TAB PUNCHLIST

L05325_Central Avenue & Colvin Avenue (NY)...

944 Central Avenue, Albany, New York

M-201

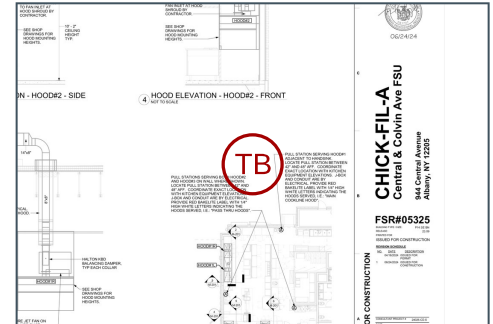
#12 ANSUL Pull stations are not labled

All ANSUL pull stations are not labeled. See page M-201 for acceptable spec.

M-701

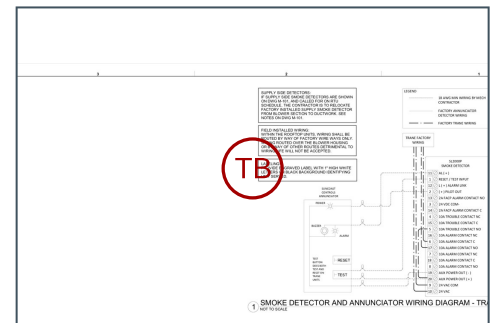
#8 Annunciators are not labeled

Annunciators are not labeled. See page M-701 for spec.

M-701

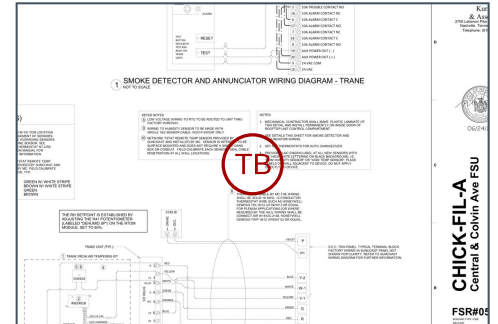
#7 Sensors are not labeled

Temp and humidity sensors are not labeled. Refer to page M-701 note #4 for exact specifications.
